# Access Compliance Report

### (Curb Ramps)

Intersection ID: 10020275	Main Street: AYRSLEY_TOWN_BV	Cross Street: N/A	Location: S
ADA ID: 0C5CE8F323C4	Ramp Type: BlendTrans2	Initial Pass/Fail: Pass	Overall Compliance: No
Severity Score: 2.5			
Codes/Mitigation Info/Possible Solution		Field Measurements/Component Compliance

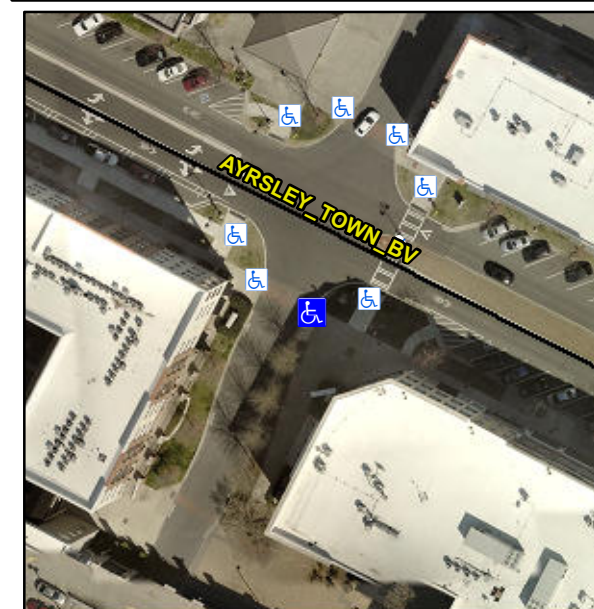
**Remove & Replace Curb Ramp With Two New Directional Ramps or Equivalent.**

**XWALK PAVERS**

**R304.2.3, R305.1.4, R305.2**
